Addendum 01

Project:	M&T Bank Stadium HVAC Controls, Lighting Controls and Submetering Systems Improvements	Date:	April 7, 2021
Subject:	Addendum 01	BKM Project No:	20092.01

The proposed additions, deletions, or modifications to the Bid Documents, dated February 12, 2021, are as follows:
Incorporate clouded revisions identified by a Delta 1, dated 04/02/2021.

SHEET TITLE:
BUILDING AUTOMATION
SYSTEM - GENERAL NOTES &
NETWORK ARCHITECTURE

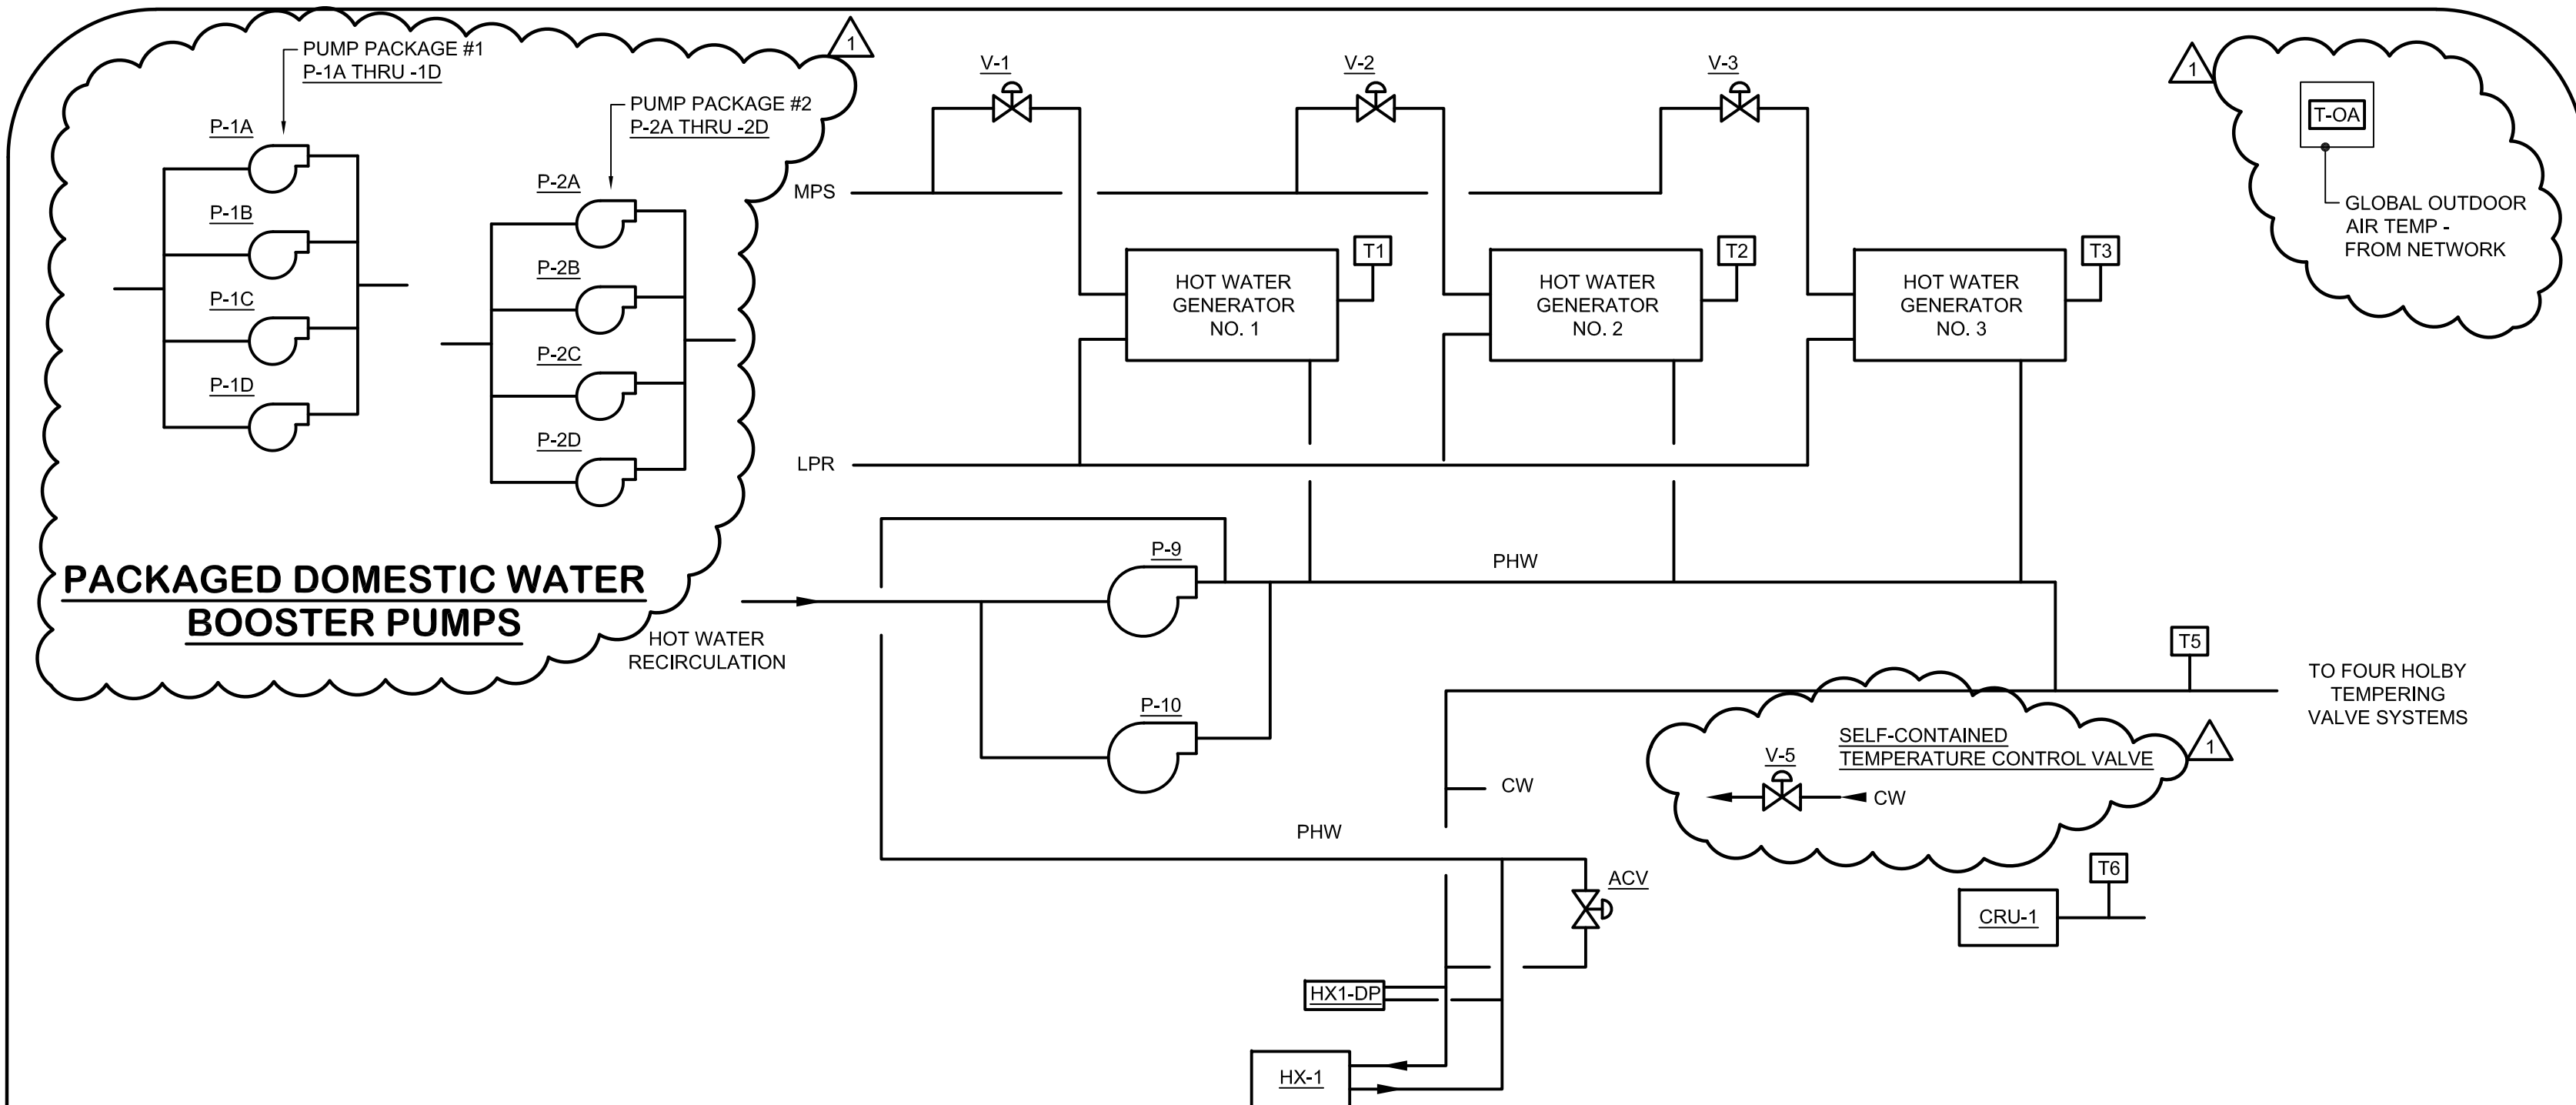
Drawing M4.11 – Automatic Temperature Controls

- ATC General Notes: modified as follows:
 - Added Note 16. ATC Control Valves for heating shall fail full-open. ATC Control Valves for cooling shall fail to the last position. Failure shall be alarmed at the BAS.
- Revised name of "BAS Network Diagram" to "iBMS Network Architecture Diagram".

DOMESTIC HOT WATER SYSTEM CONTROL

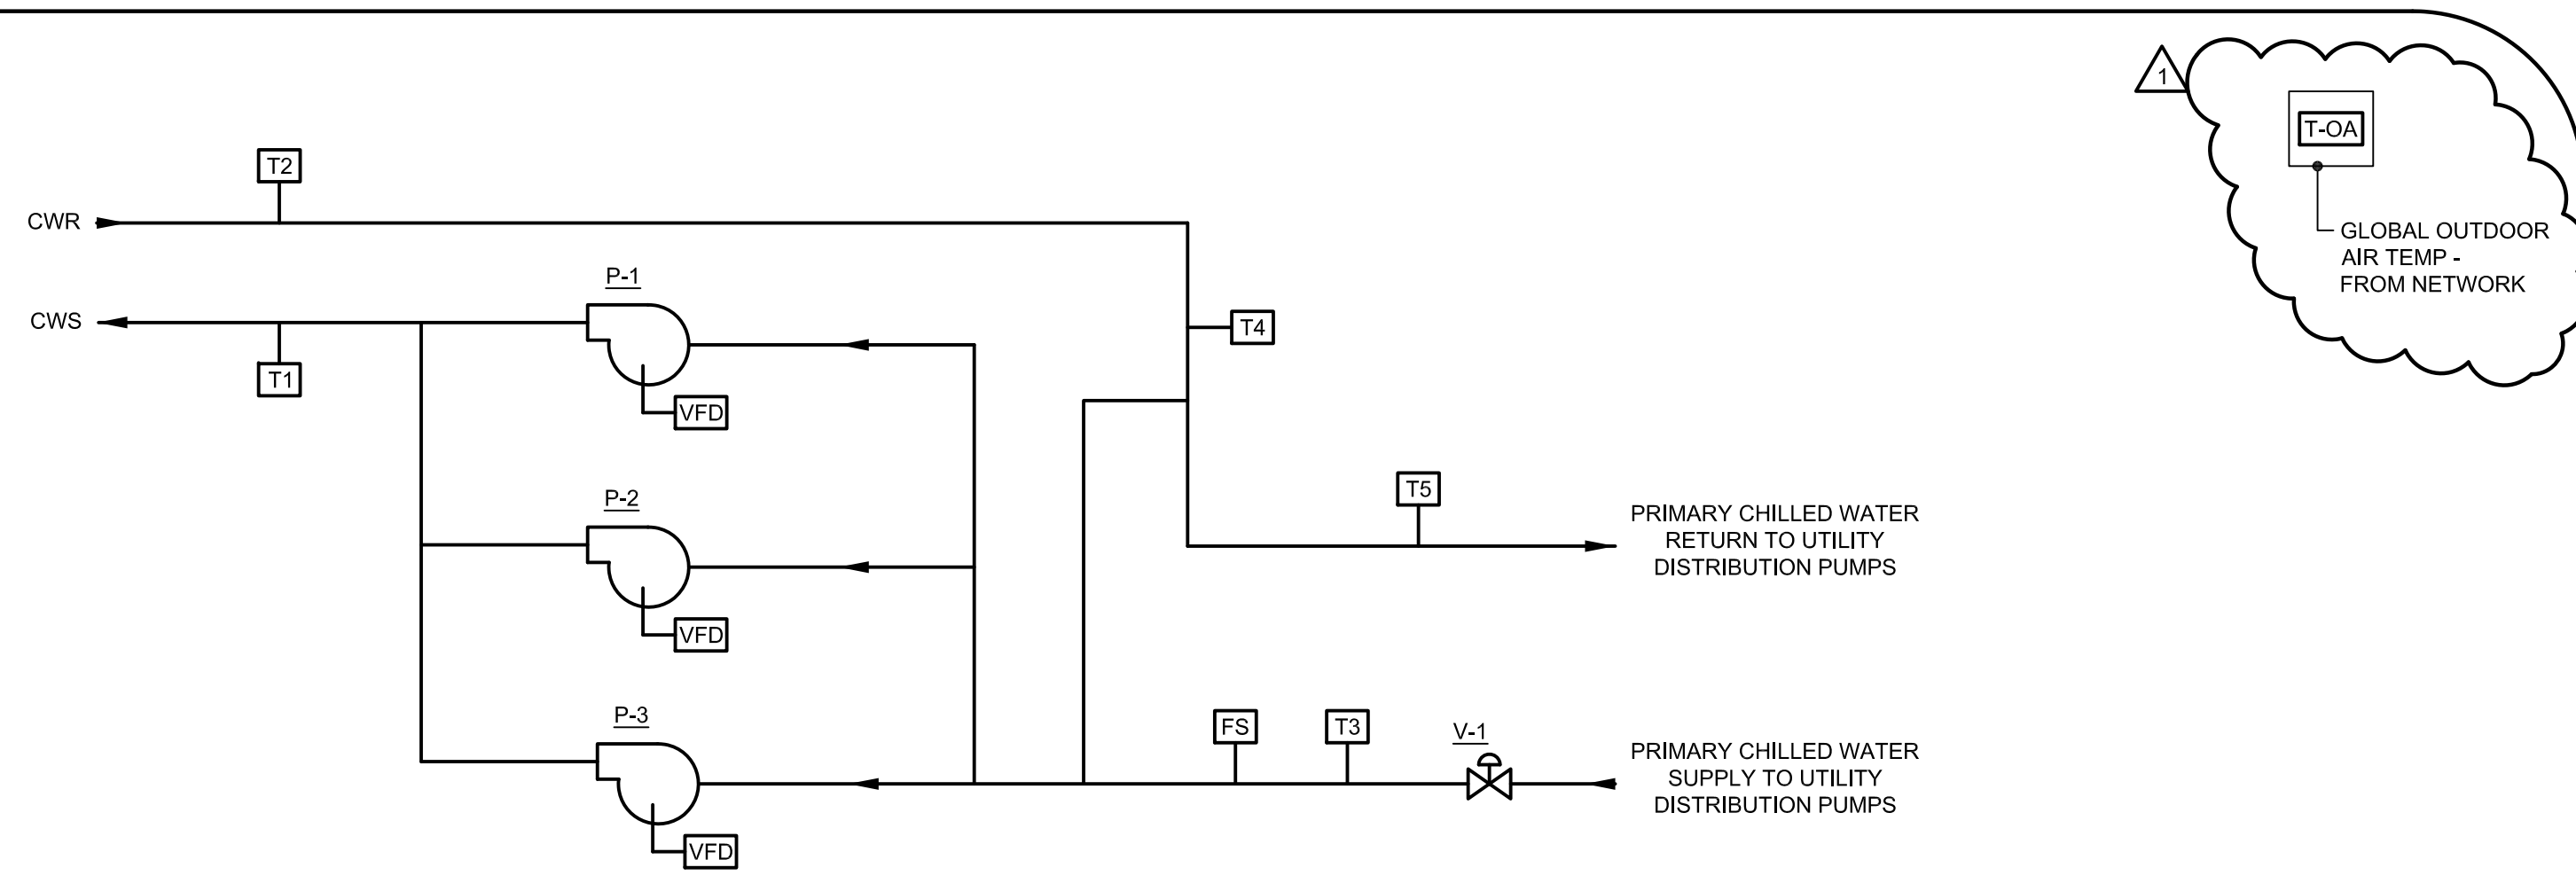
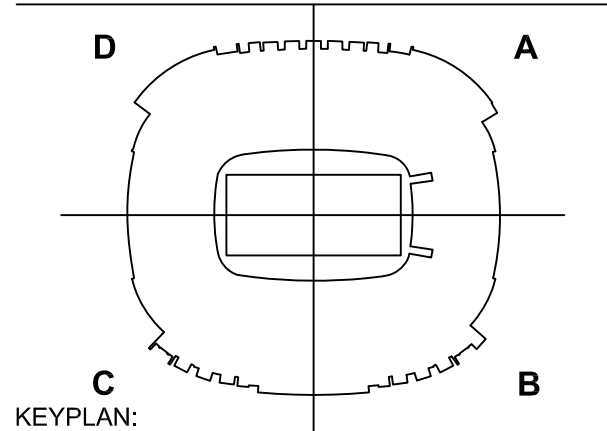
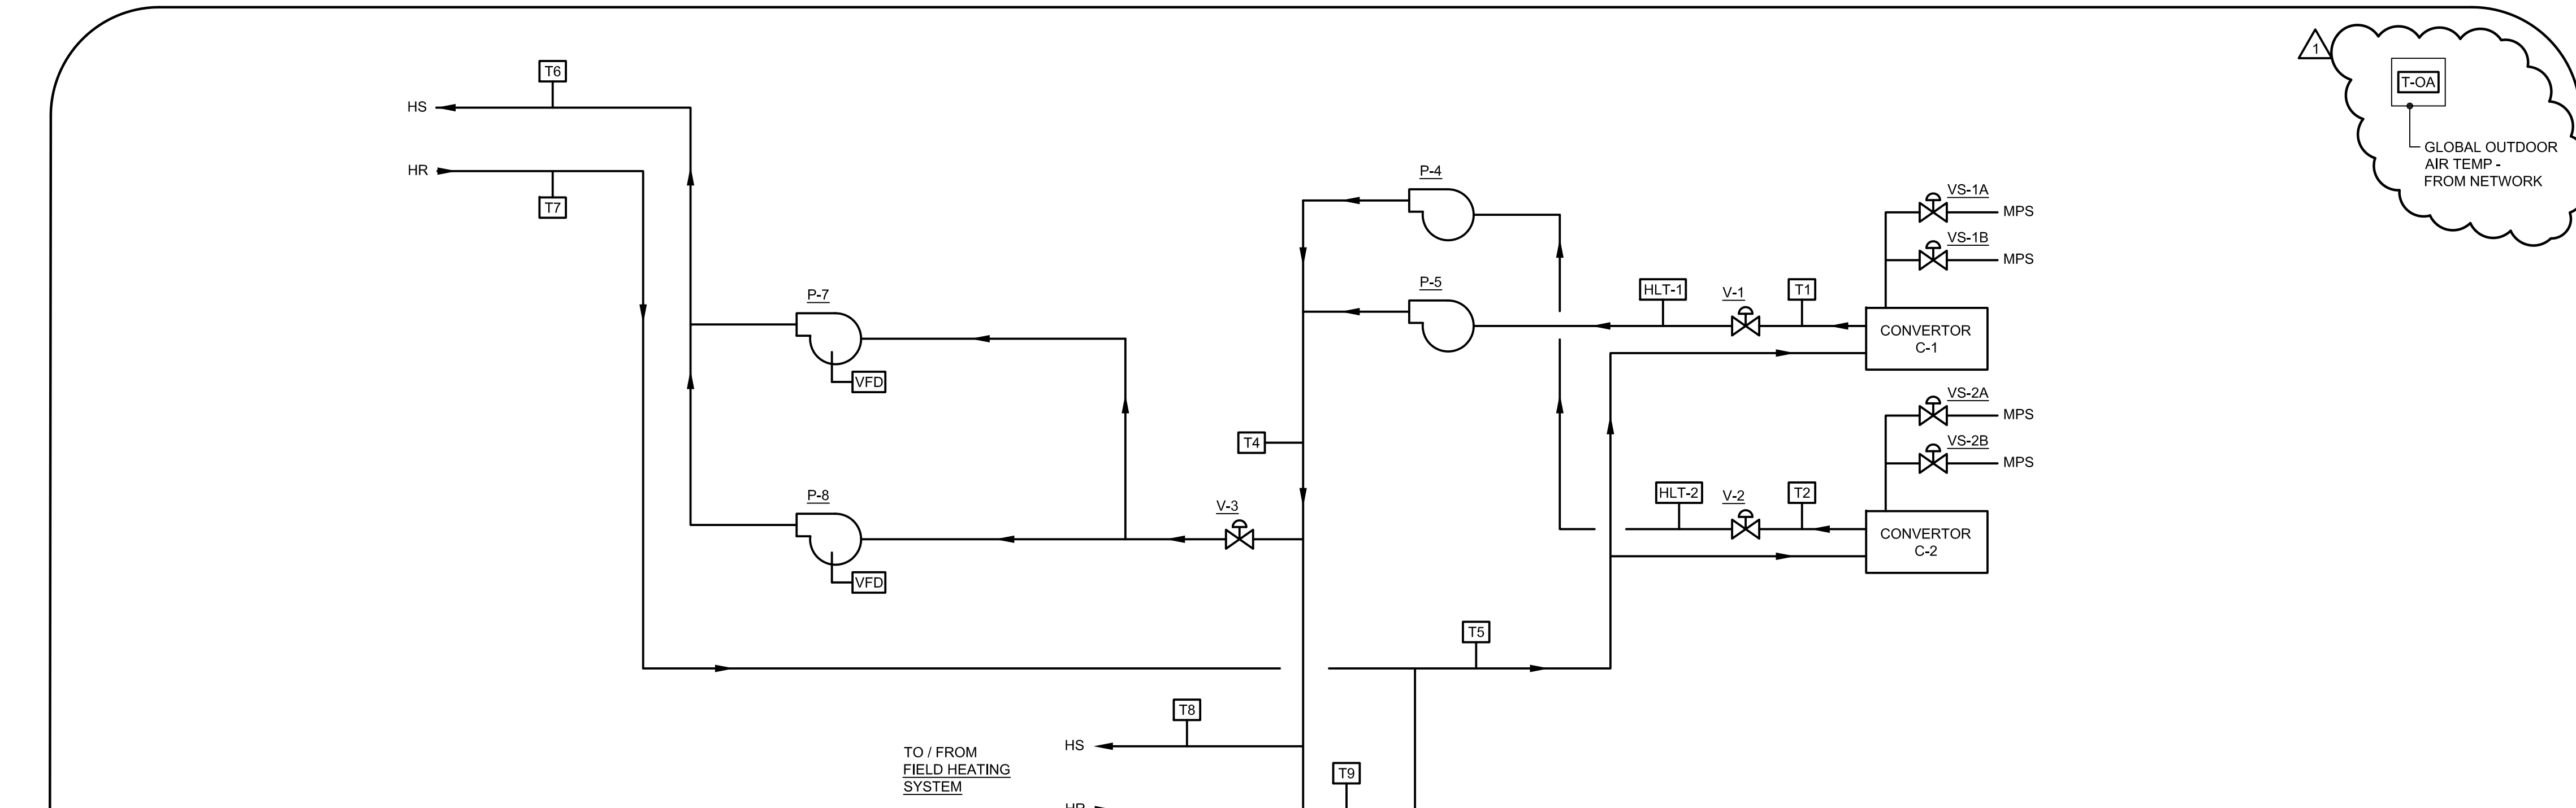
Drawing M4.21 – Automatic Temperature Controls

- Domestic Hot Water System Control, Chilled Water System Control, & Heating Water System Control modified as follows:
 - Noted that Outdoor Air shall be read from the Global Outdoor Air Across Network. System shall work off the average.
- Domestic Hot Water System Control:
 - Packaged booster pumps shown for clarity
 - Self-contained temp control valve, V-5, shown for clarity.
- Chilled Water System Control, & Heating Water System Control modified as follows:
 - Pumps shall adjust to meet demand of all DP transmitters.
- Space Control / General Exhaust Fan Control modified as follows:
 - Added fans shall operate off of a "winter mode" and "non-winter mode" schedule.

HVU-4 CONTROL

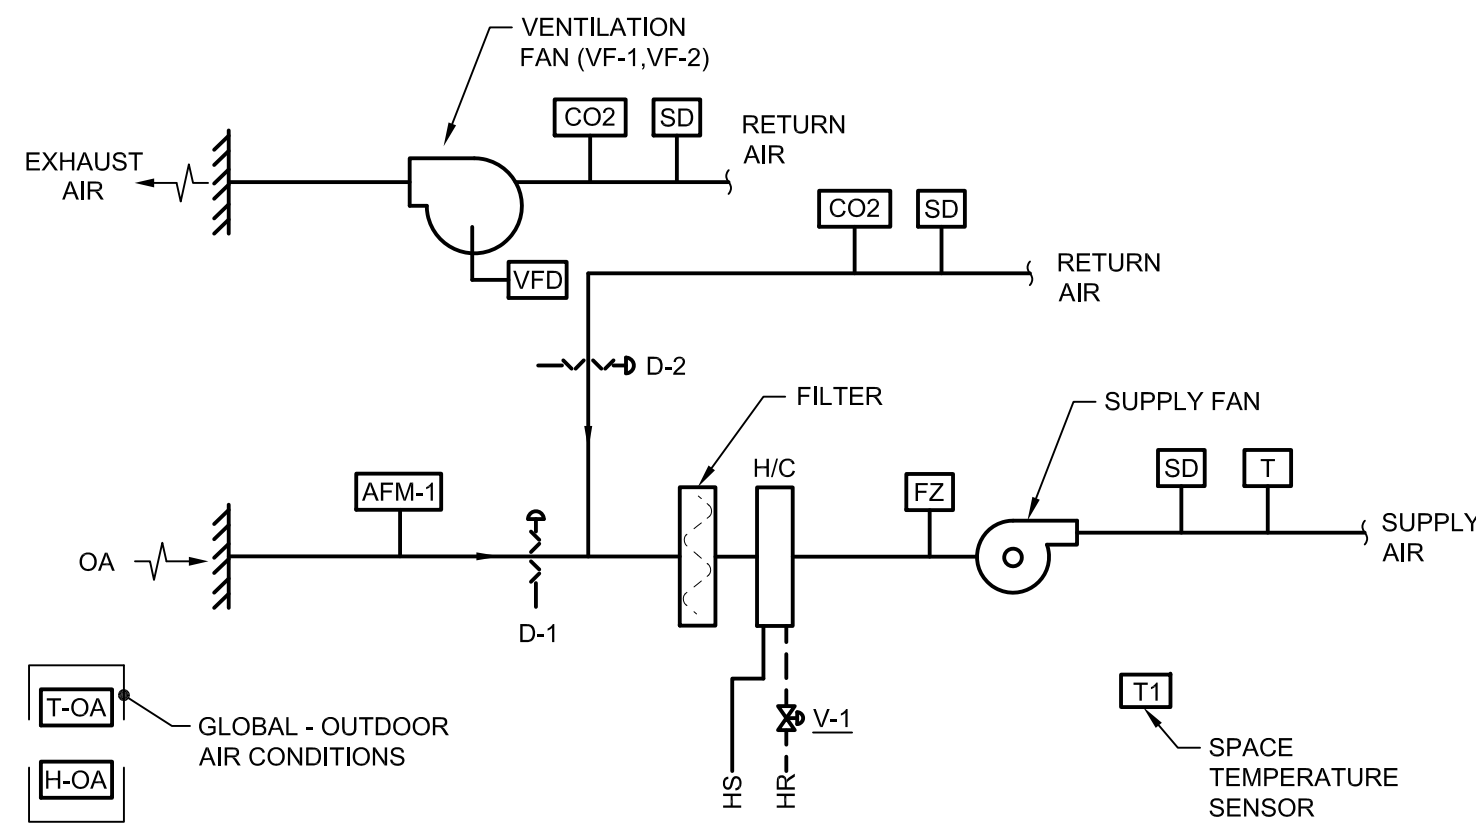
2. All HVU Control modified as follows:
 - a. Modified warm-up mode.
 - b. Modified freeze protection operation.
3. HVU-4 Control modified as follows:
 - a. Removed the "Occupied Ventilation Mode".
4. HVU-5 & HVU-7 Control modified as follows:
 - a. Removed return air. (per MSA's confirmation that the units do not have Return Air)
5. AHU-6 Controls modified as indicated with clouds.
